UNITED STATES PATENT AND TRADEMARK OFFICE

APPLICATION NO.	FILING DATE	FIRST NAMED INVENTOR	ATTORNEY DOCKET NO.	CONFIRMATION NO.
10/537,481	11/14/2005	Christopher Thomas Elsworthy	11136/228	3347
28455 7590 11/15/2007 WRIGLEY & DREYFUS 28455 BRINKS HOFER GILSON & LIONE P.O. BOX 10395 CHICAGO, IL 60610				
EXAMINER				
MULLER, BRYAN R				
ART UNIT		PAPER NUMBER		
3723				
MAIL DATE		DELIVERY MODE		
11/15/2007		PAPER

Office Action Summary

DETAILED ACTION

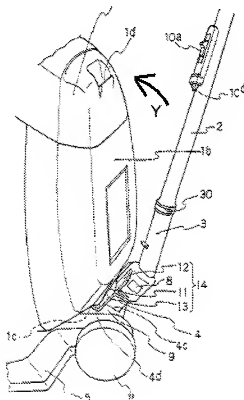
11. In reference to claim 5, Yoshimi further discloses that, to engage the first and second catch formations, a user would inherently have to place the main unit (1) onto the first catch structure (4d) on the cleaning head, which will be moving the wand upwardly relative to the main unit, and then pivot the wand relative to the main unit (in

the direction of arrow Y below), which inherently includes a vector of movement upward relative to the main unit. Therefore, the second catch formations of Yoshimi are engagable by an upward movement of the wand, both immediately prior to (during placement of main unit on formation 4d) and during engagement (rotational motion having vector of movement upward) of the formation (10) on the wand with formation (1d) on the main unit.

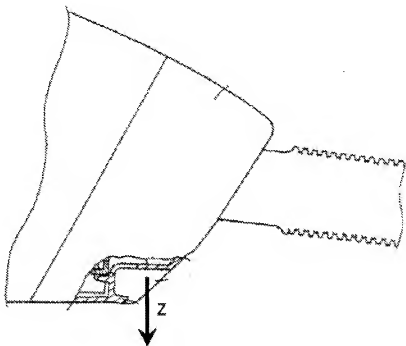
12. In reference to claim 6, the second catch formation (1d) on the main unit is a recess that may be considered to be downwardly facing (as shown by arrow Z below) when the main unit is in the orientation to be used as a separate canister, wherein the lower surface 1b is positioned on or parallel to the ground (shown in Fig. 13), and the

wand comprises a complementary projection (10) that is engagable with the recess (1d).
